MIL-S-19500/375C
AMENDMENT 1
11 August 1995

SEMICONDUCTOR DEVICE, TRANSISTOR, FIELD-EFFECT,
N-CHANNEL, DEPLETION MODE, SILICON
TYPES 2N3821, 2N3822, 2N3823
JANTX, JANTXV, AND JANS

This amendment forms a part of MIL-S-19500/375C, dated 15 September 1993, and is approved for use by all Departments and Agencies of the Department of Defense.

FIGURE 3. Physical dimensions, (similar to TO-72)."

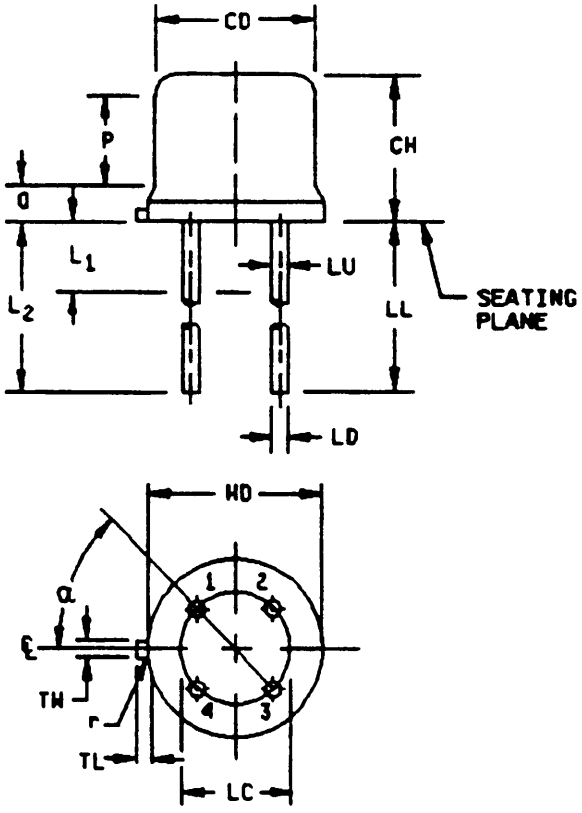
3.3, delete "MIL-S-19500, appendix F, figure 10." and substitute "figure 3 herein".

Add the following new figure 3:
